Response to
Request for Additional Information No. 248, Supplement 3

U.S. EPR Standard Design Certification
AREVA NP Inc.
Docket No. 52-020
SRP Section: 03.04.02 - Analysis Procedures
SRP Section: 03.07.01 - Seismic Design Parameters
SRP Section: 03.07.02 - Seismic System Analysis
SRP Section: 03.08.01 - Concrete Containment
SRP Section: 03.08.03 - Concrete and Steel Internal Structures of Steel or
Concrete Containments
SRP Section: 03.08.04 - Other Seismic Category I Structures

Application Section: FSAR Ch 3

QUESTIONS for Structural Engineering Branch 2 (ESBWR/ABWR Projects) (SEB2)

Figure 3.7.2-43-5—Center of EPGB Basemat Transfer Functions (Node 1179), Elev. 0'0", X-Direction, 2sn4um profile

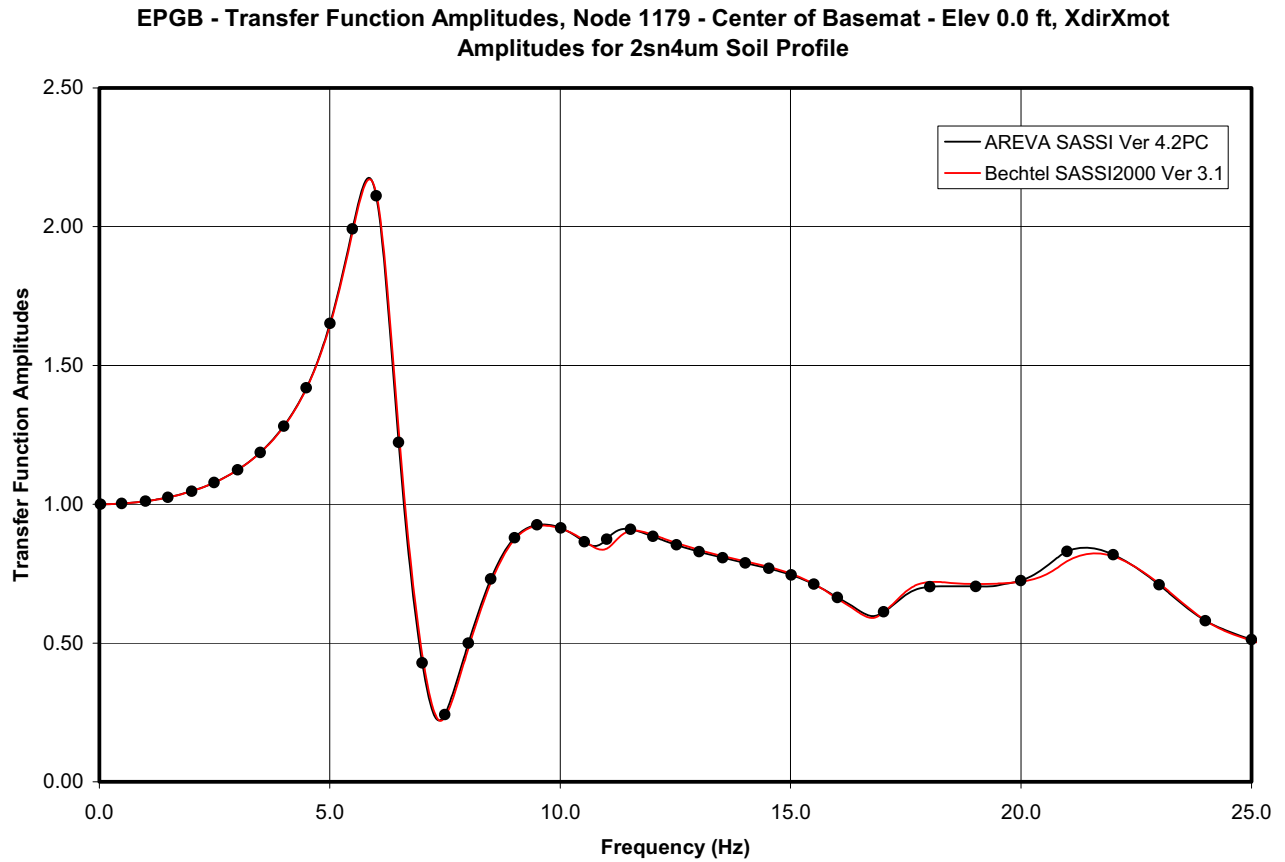
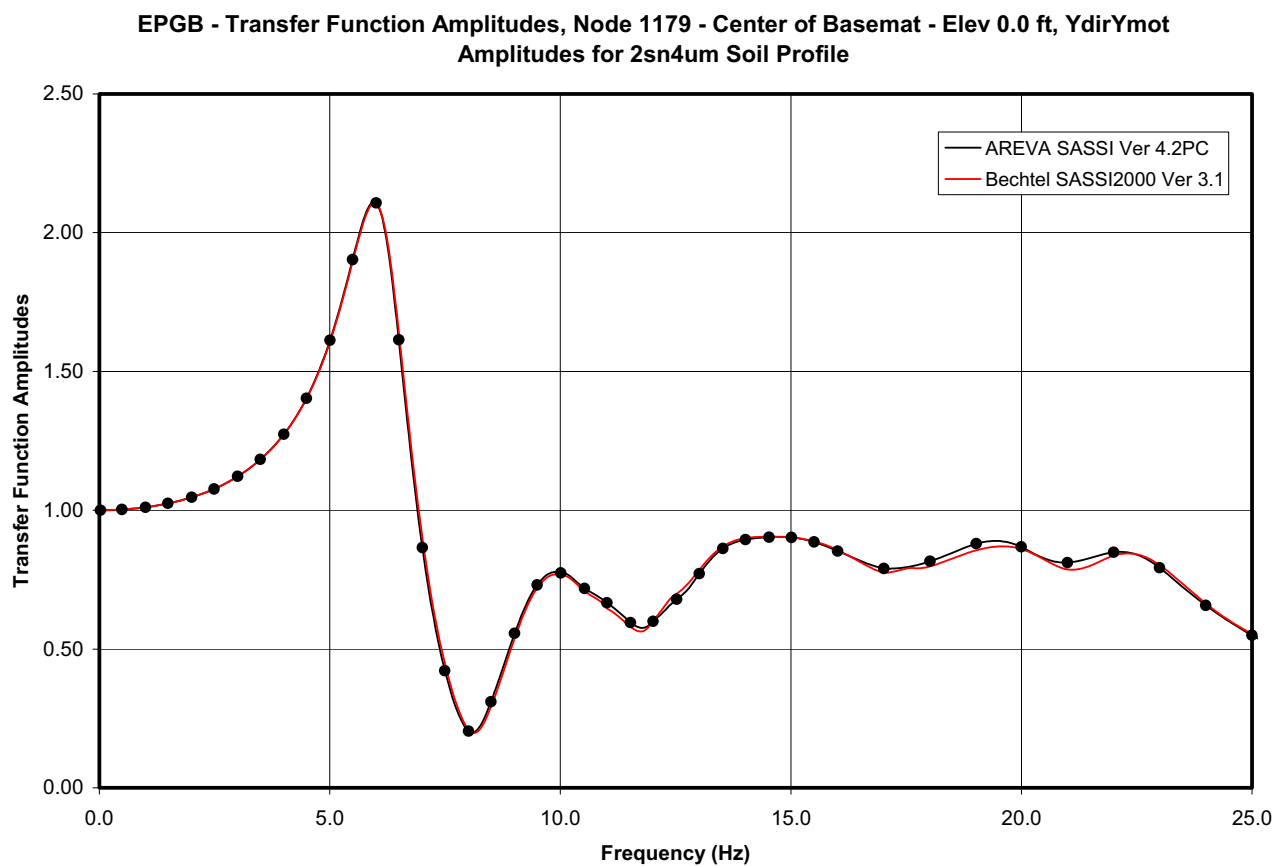
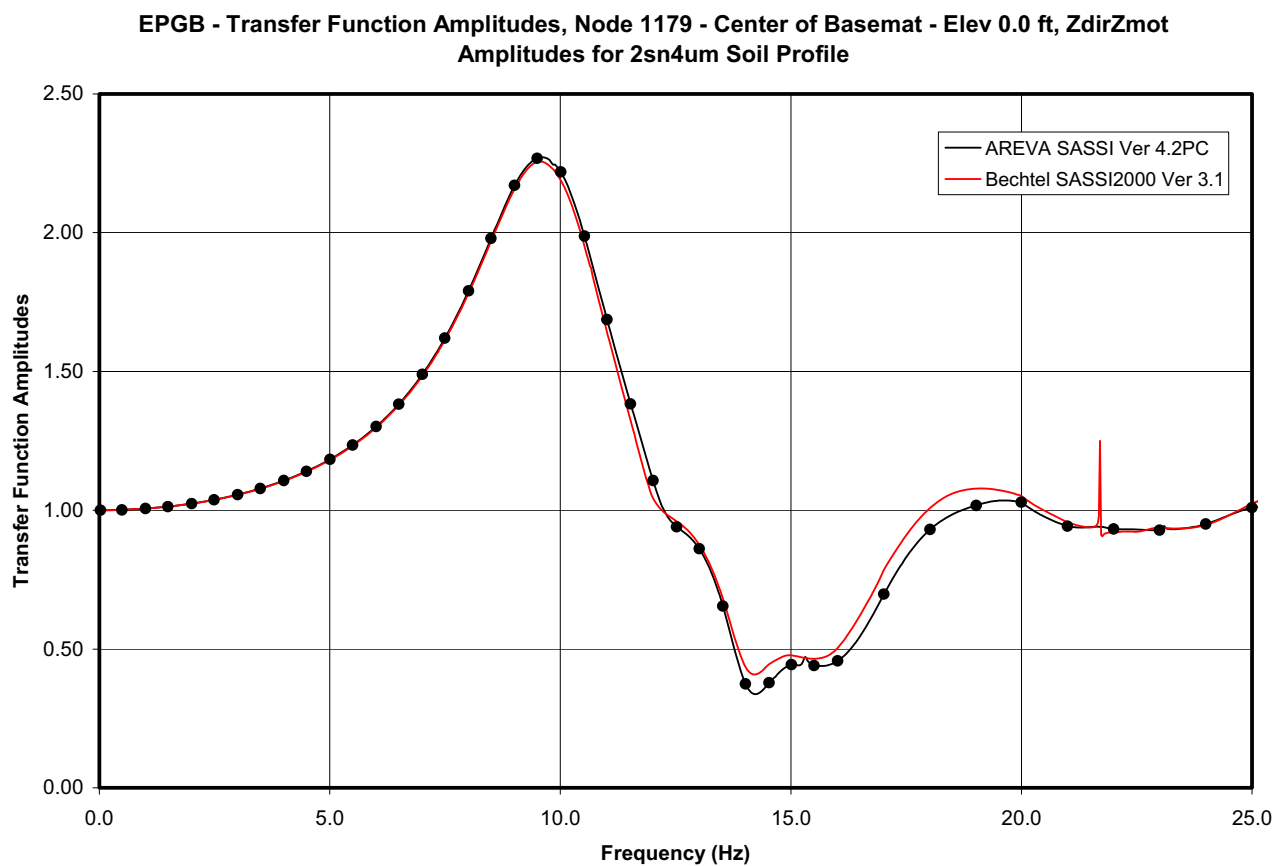
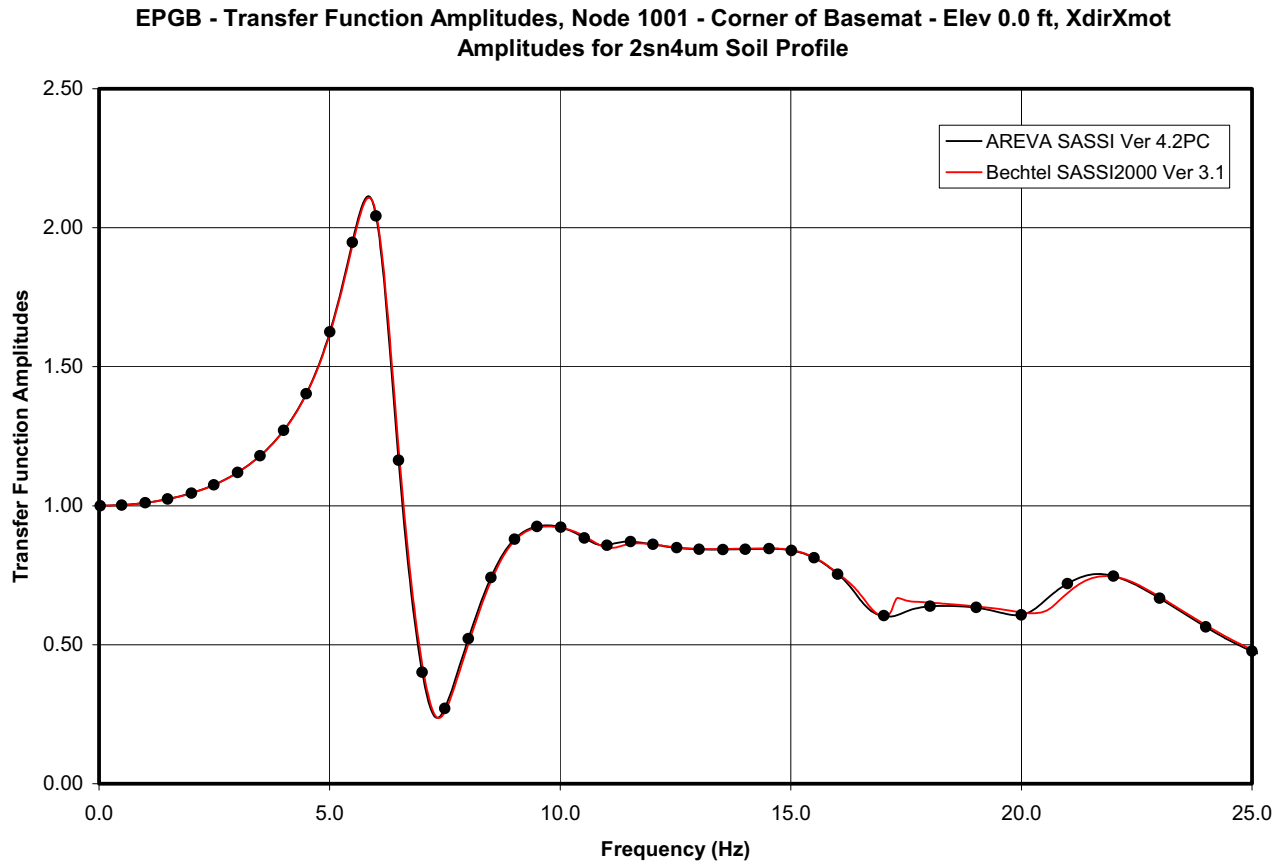
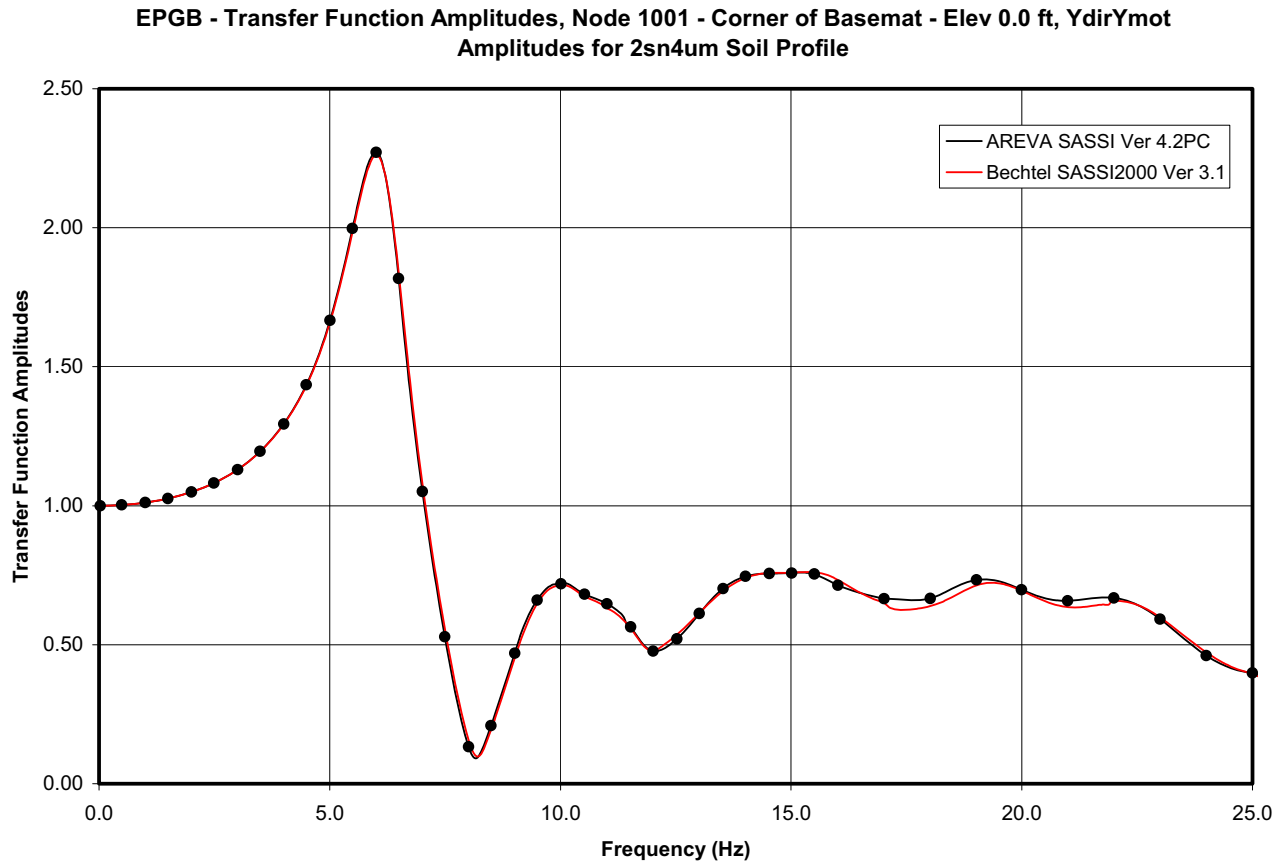
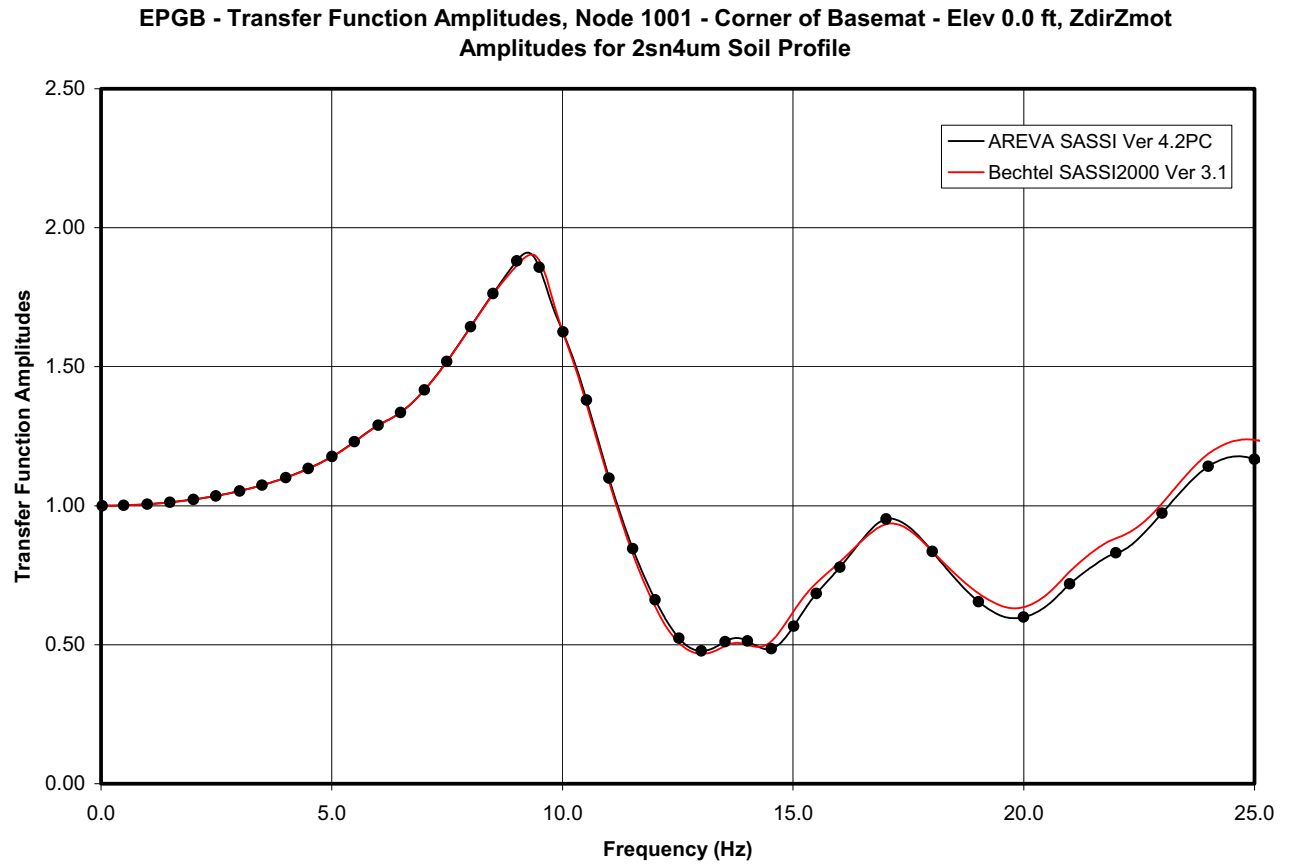
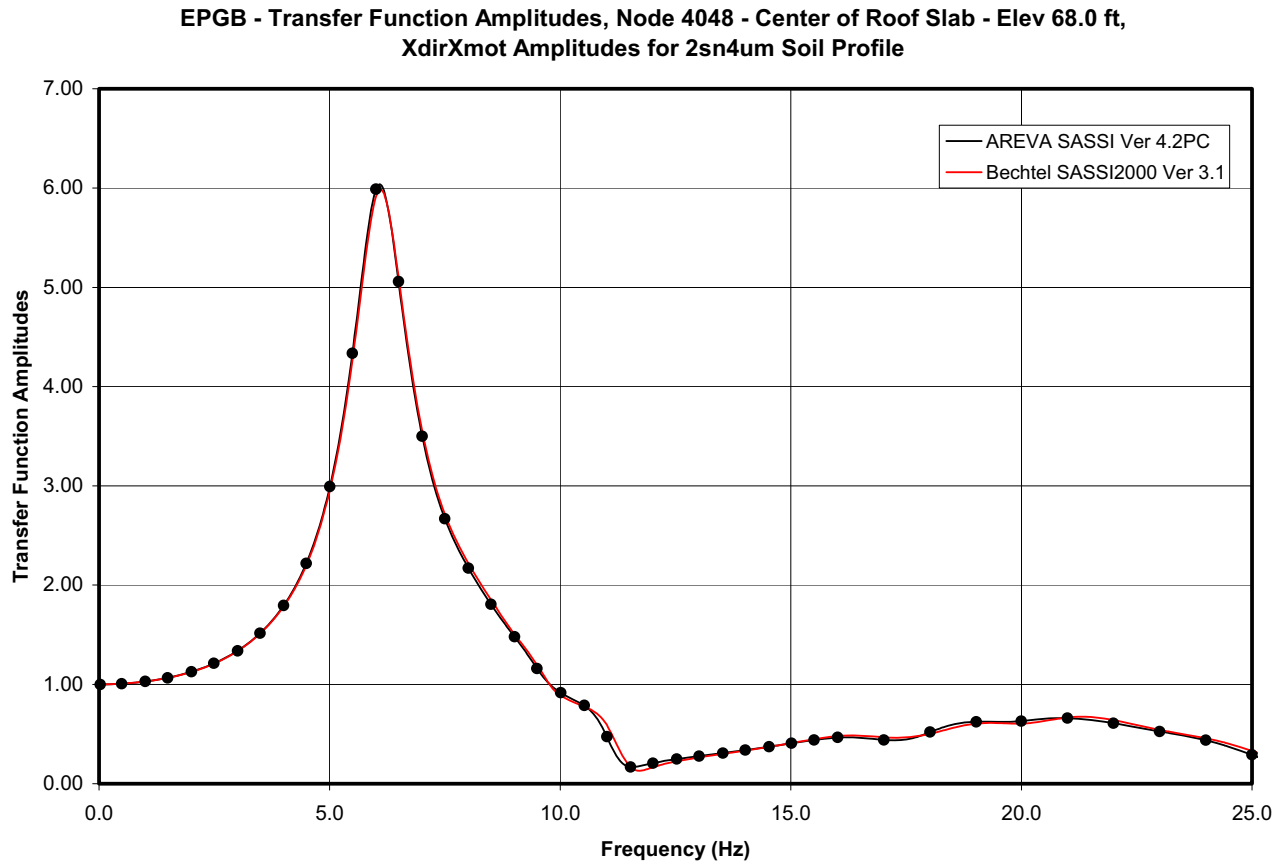
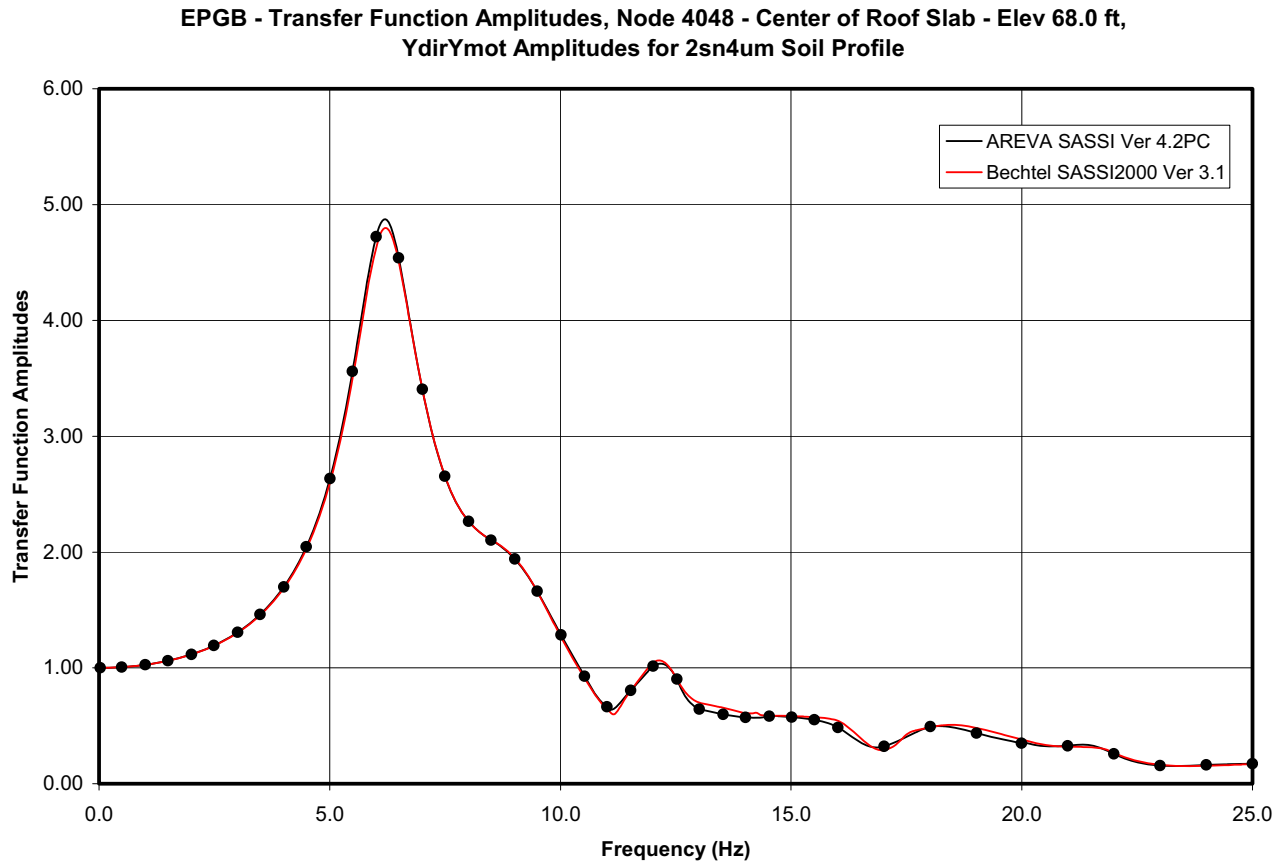
The response states that the two versions of the code are functionally the same and produce equivalent results with no significant differences. However, it does not provide a comparison of results from a building seismic analysis using the two versions (AREVA SASSI v. 4.1B and Bechtel SASSI2000, v. 3.1) as requested in Question 03.07.02-1. Because each code is being used in the analysis of Seismic Category I structures, it should be demonstrated that the codes provide similar results for the SSI analysis. The applicant is requested to run an analysis of an embedded seismic Category I structure using both versions of the code and demonstrate that the seismic response of the structure is similar for each of the programs.

Figures 3.7.2-43-5 through 3.7.2-43-13 show the transfer function comparisons in the three directions for the above nodes. The results show that the seismic response of the structure is comparable for each of the programs.
